Groundwater Application Review Summary Form

Application # G- 18399

TO: Water Rights Section Date 05/17/2017
 FROM: Groundwater Section Dennis Orłowski
 SUBJECT: Application G- 18399 Supersedes review of _____
 Reviewer's Name
 Date of Review(s)

A. GENERAL INFORMATION: Applicant's Name: Utokia Farms LLC (A. Teuscher) County: Clackamas

Figure 2 Hydrograph – area wells (static only)

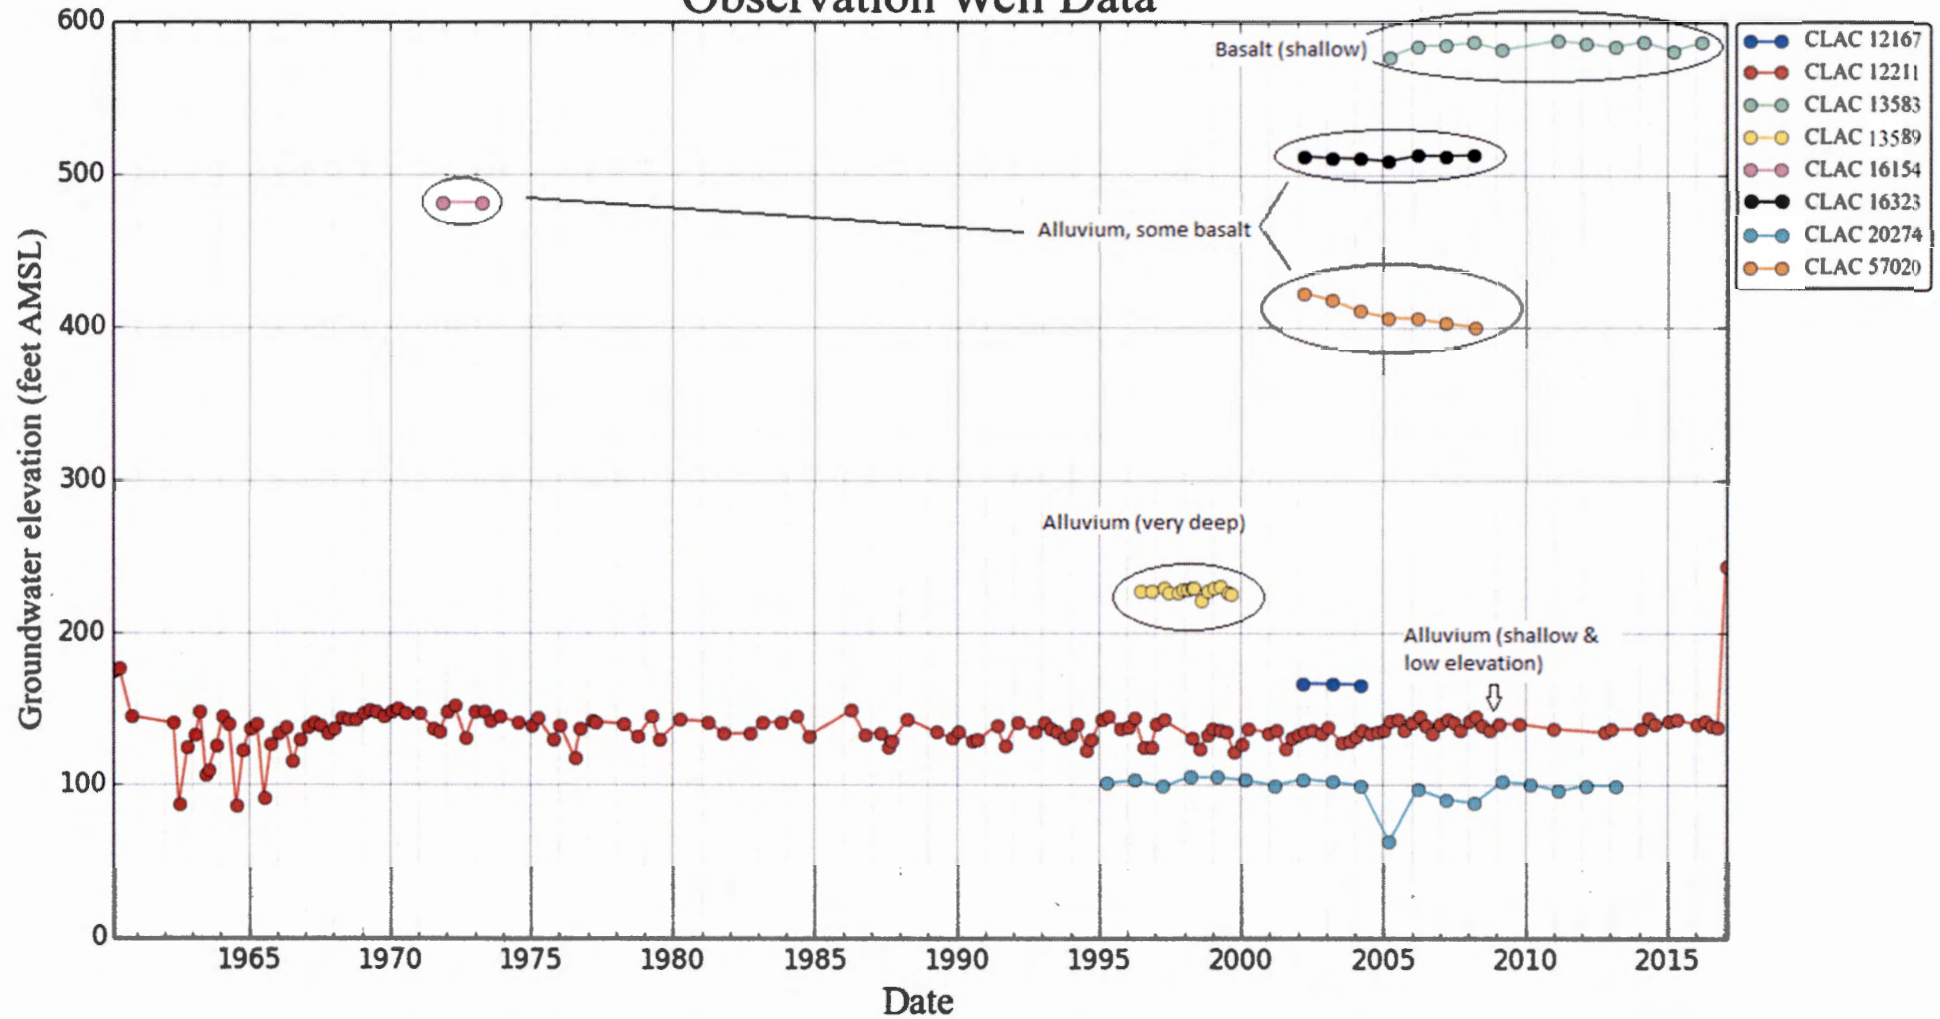
Available groundwater level data for most area wells completed in both alluvial and Boring Lava basalt aquifers have been generally stable for the past 10-plus years. One exception is CLAC 57020, located about 2.3 miles northeast of the proposed POA and with a similar completion depth/aquifer type, that experienced more than a 22-ft decline from 2001 to 2008. Thus, despite the low requested allocation for this application and general groundwater level stability in the area, but because of the limited extent and low storage capacity of these aquifers, the following permit conditions are recommended to protect the resource:

- 7N: annual measurement condition
- Medium water-use reporting

Figure 3 Water availability tables

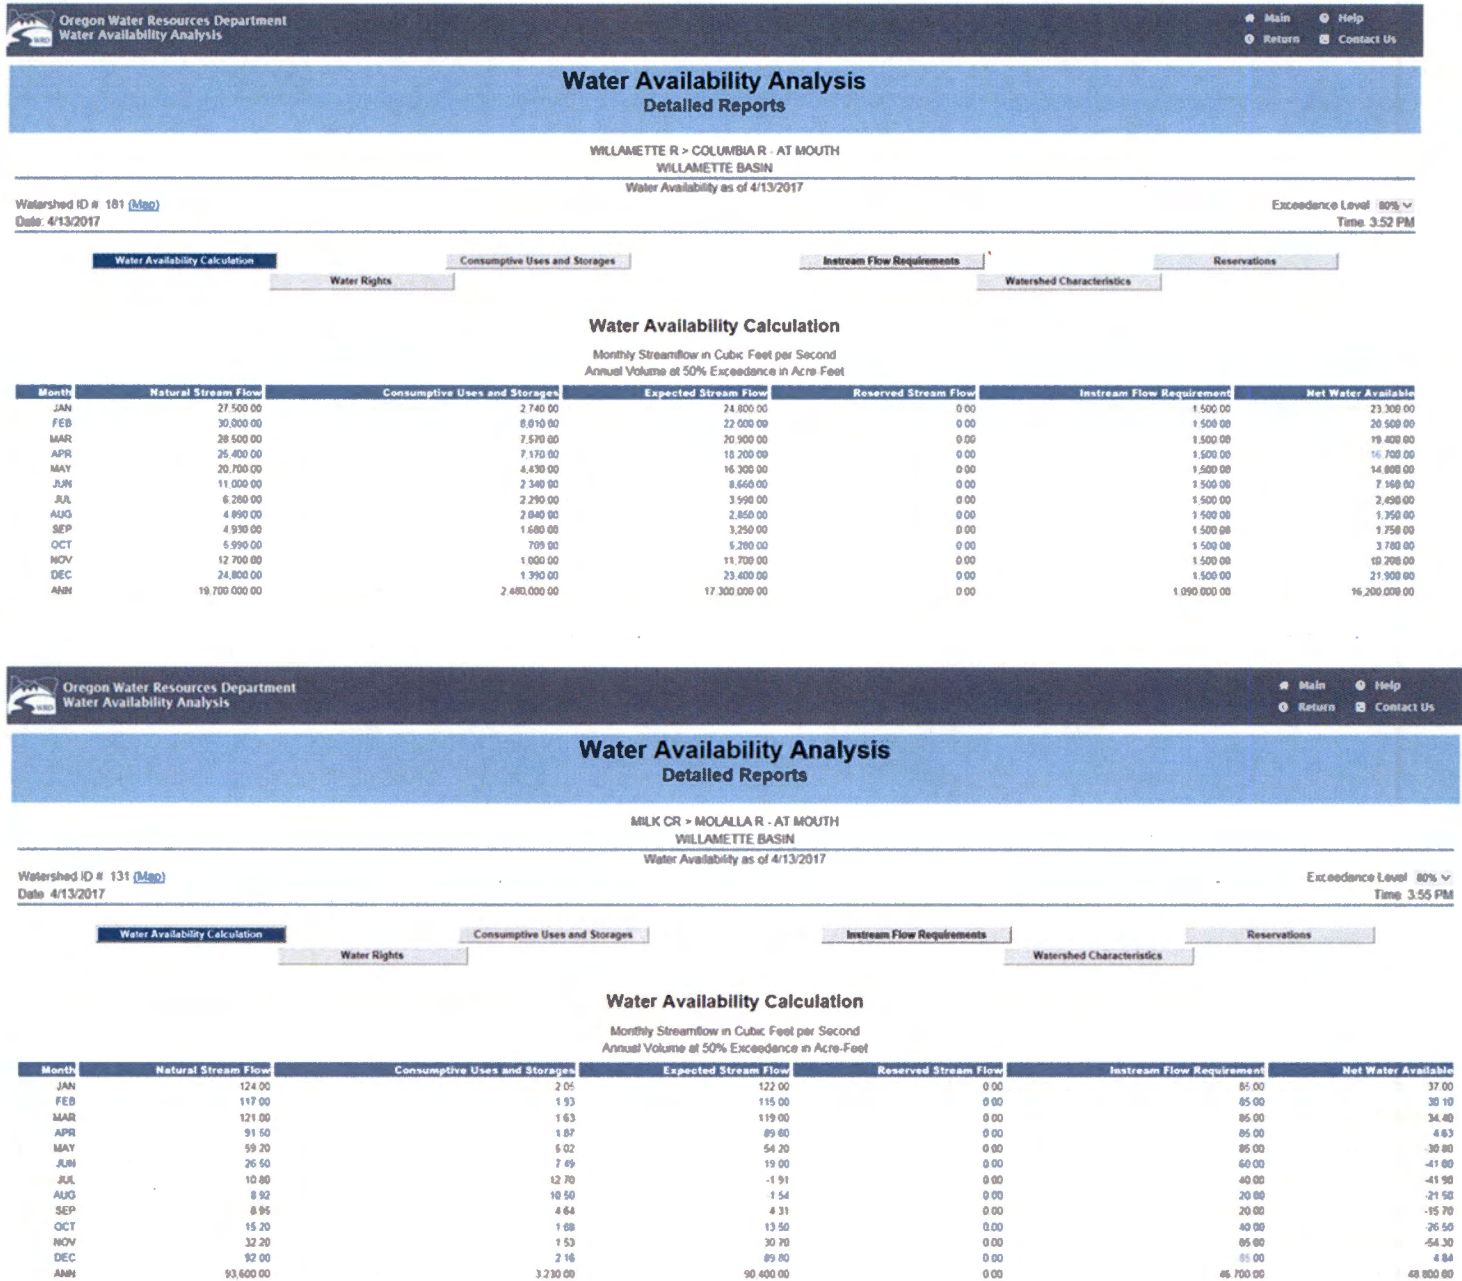
SW2 & SW3: Milk Creek > Molalla River – at mouth (Figure 3)

C4a: the WAB for SW2 and SW3 is the Milk Creek > Molalla River – at mouth. For this WAB, 1% of the lowest natural flow is 0.0892 cfs (August). Because this exceeds the requested allocation of 0.0356 cfs, this evaluation is not required.
